Access Compliance Report

Public Rights-of-Way

(Curb Ramps)

Intersection ID: 48633	Main Street: GRANDE HEIGHTS DR	Cross Street: MILLSTREAM RIDGE DR	Location: S
ADA ID: F6AAE123909B	Ramp Type: BlendTrans1	Initial Pass/Fail: Pass	Overall Compliance: No
Severity Score: 22.75			
Codes/Mitigation Info/Possible Solution		Field Measurements/Component Compliance

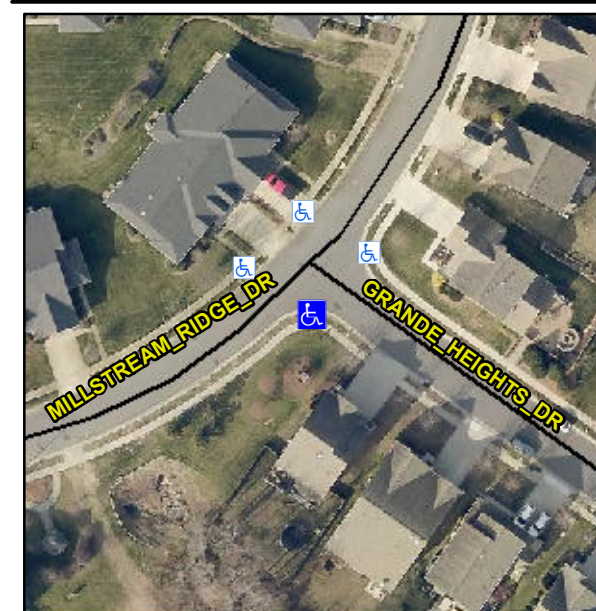
Not Found, R304.5.3, R305.1.4, R302.7.2, R304.5.4

Compliance	Description	Data	Compliance	Description	Data
N/A	Ramp Length (in)	47.0	Yes	BlendTrans Slope (%)	4.7
Yes	Ramp Width (in)	48.0	No	BlendTrans XSlope (%)	4.1
N/A	Flare Type LT	Sloped	N/A	Flare Type RT	Sloped
N/A	Flare Slope LT (%)	4.4	N/A	Flare Slope RT (%)	1.4
N/A	Flare Traversable LT?	No	N/A	Flare Traversable RT?	No
Yes	Landing Length (in)	50.5	Yes	DWS Provided?	Yes
Yes	Landing Width (in)	48.0	Yes	DWS Contrast?	Yes
Yes	Landing Slope (%)	1.3	Yes	DWS Length (in)	24.5
No	Landing X Slope (%)	4.4	No	DWS Full Width?	No
N/A	Landing Curb? (Y/N)	No	Yes	DWS Offset (in)	2.0
N/A	Shared Landing?	No			
Yes	Gutter Ponding?	No	No	Gutter Slope (%)	6.2
No	Gutter Lip Ht (in)	1.0	No	Gutter X Slope (%)	3.9
N/A	Painted X Walk1?	No	N/A	Painted X Walk2?	No
	X Walk 1 Direction	To NE		X Walk 2 Direction	To NW
	X Walk 1 Width (in)	N/A		X Walk 2 Width (in)	N/A
	X Walk 1 Slope (%)	3.5		X Walk 2 Slope (%)	4.0
	X Walk 1 X Slope (%)	2.5		X Walk 2 X Slope (%)	2.7

N/A	Ramp inside XWalk1?	N/A	N/A	Ramp inside XWalk2?	N/A
	Road Slope (%)	4.6		Clear Space?	Yes
	Road X Slope (%)	0.8	N/A	Clear Space to XWalk (in)	N/A
Yes	Any Obstructions?	No	Yes	Storm Grate/Utility Hazard?	No
	Obstruction Type			Storm Grate/Utility Type	
		N/A			N/A
			Yes	Surface Condition? (G/P)	Good
			No	Curb Slope (%)	13.9

Remove & Replace Curb Ramp With Two New Directional Ramps or Equivalent. Remove & Replace Gutter.
